PHILADELPHIA ELECTRIC COMPANY

Subject: Peach Bottom Atomic Power Station, Units 2 and 3  
Inservice Testing Program

The purpose of this letter is to submit a new Relief Request 10-VSR-3 and the associated Valve Table changes. This new Relief Request applies only to PBAPS Unit 2, and is being submitted for NRC approval prior to implementation.

RELIEF REQUEST NO. 10-VRR-3, REVISION 0

Peach Bottom Atomic Power Station, Units 2 and 3  
 Simplified Diagram for IST  
 Relief Request 10-VRR-3

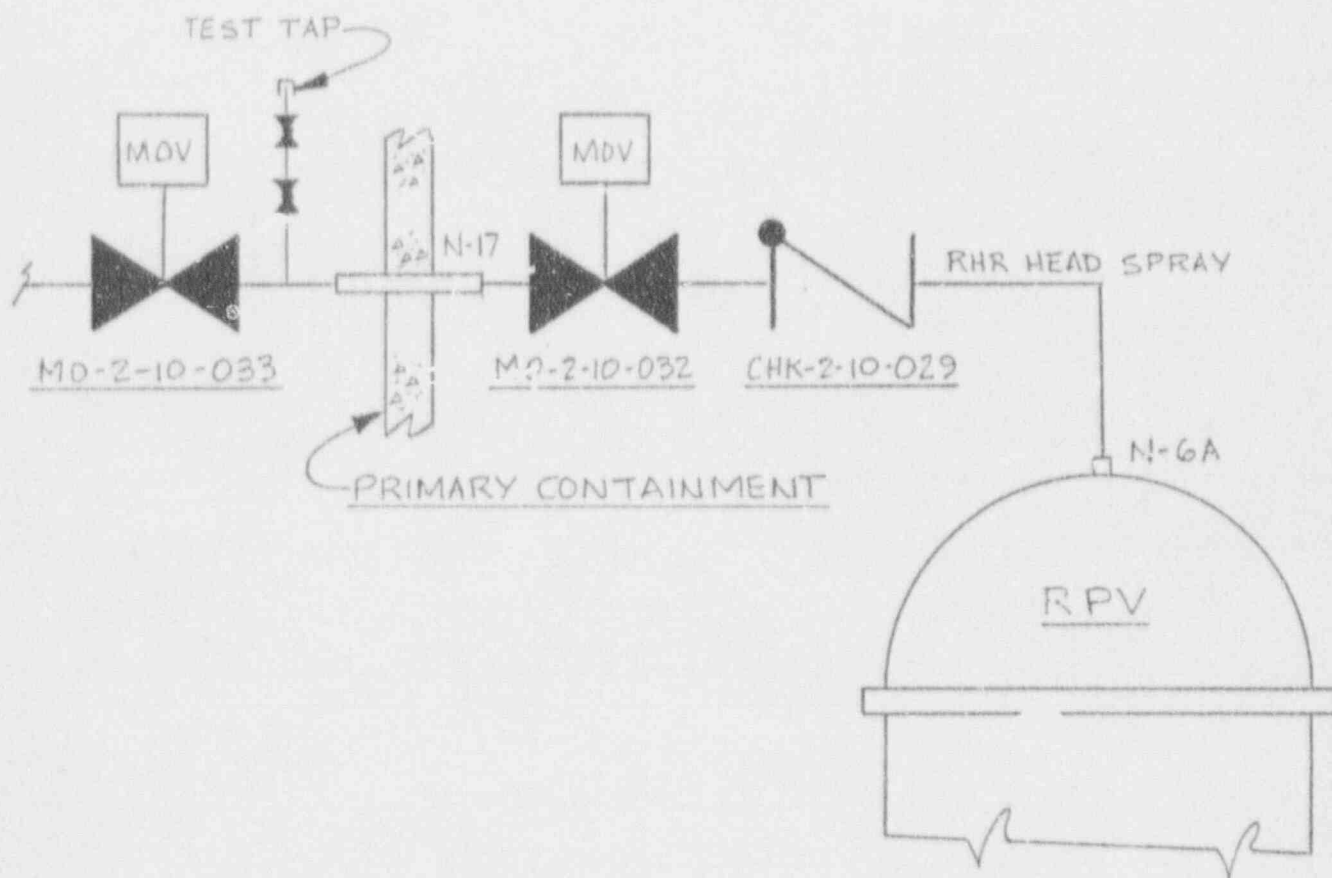
Relief Request 10-VRR-3 requests relief from testing check valve CHK-2-10-029 individually and permits it to be tested as part of a pair with gate valve MO-2-10-032. These two valves, along with gate valve MO-2-10-033 are located on the Residual Heat Removal (RHR) head spray line. A simplified diagram of the valve configuration is provided as an enclosure to this letter. This configuration of having three valves in series, allows two of the valves to be tested as a pair, thereby constituting a single pressure isolation valve (PIV) barrier, while leaving the third valve to serve as the second PIV barrier. As described in the

The valves listed above, along with gate valve MO-2-10-033 are located in the RHR head spray line on Unit 2. The RHR head spray has no safety function and no credit for its use has been taken in any accident or transient analysis or the emergency operating procedures and is not part of the plant Technical Specifications. Because head spray is not used, gate valves MO-2-10-032 and MO-2-10-033 have been administratively locked closed and de-energized as noted in P&ID M-361 Sheet 1. Although the head spray is not used, the piping penetrates primary containment and communicates directly with the reactor pressure vessel; therefore, the valves must be tested in accordance with ASME Section XI and 10CFR50 Appendix J Type C. Gate valve MO-2-10-033 is not affected by this relief request but is included to help clarify the head spray configuration.

Check valve CHK-2-10-029 and gate valve MO-2-10-033 are the two pressure isolation valves (PIVs) for this head spray line and are tested in accordance with ASME Section XI IWV-3423. Gate valves MO-2-10-032 and MO-2-10-033 are the primary containment isolation valves (PCIVs) for head spray penetration N-17 and are tested in accordance with 10CFR50 Appendix J Type C requirements. All three of these valves are normally closed and do not change position to perform their intended safety function and are therefore considered passive components.

Check valve CHK-2-10-029 is located between nozzle N-6A and gate valve MO-2-10-032 and checks flow from the RPV in the direction of the gate valve. Per the requirements of IWV-3423, this check valve must be tested with the pressure differential in the same direction as when the valve is performing its intended function. Since there are no test taps between check valve CHK-2-10-029 and gate valve MO-2-10-032, gate valve MO-2-10-032 must be re-energized and opened and a test tap downstream used to measure the check valve leakage.

Periodically re-energizing and stroking gate valve MO-2-10-032 is not practical because each time the valve is stroked, the disk-to-seat interface is disturbed. This activity has the potential to adversely affect the leak tight integrity of the valve.

Instead of re-energizing and stroking gate valve MO-2-10-032, the gate valve and check valve will be leak tested in series and the valve pair will be considered a single pressure boundary. This valve pair will constitute one of the two independent PIV barriers for the RHR head spray line and MO-2-10-033 will still be considered the second PIV in this line.

Check valve CHK-2-10-029 and gate valve MO-2-10-032 will be leak tested as a pair. Both valves in the pair will be considered inoperable if testing indicates leakage through the valves exceeds the limits specified in the respective surveillance test.

This valve pair will constitute a single PIV boundary; and gate valve MO-2-10-033 is the second PIV boundary in the RHR head spray line. Each of these PIV boundaries will be tested individually to assure its leak tight integrity. Therefore, this alternate test method complies with the intent of Generic Letter 87-06 because there are two independent barriers between a high-low pressure interface, and these barriers are periodically tested to verify their leak tight integrity.
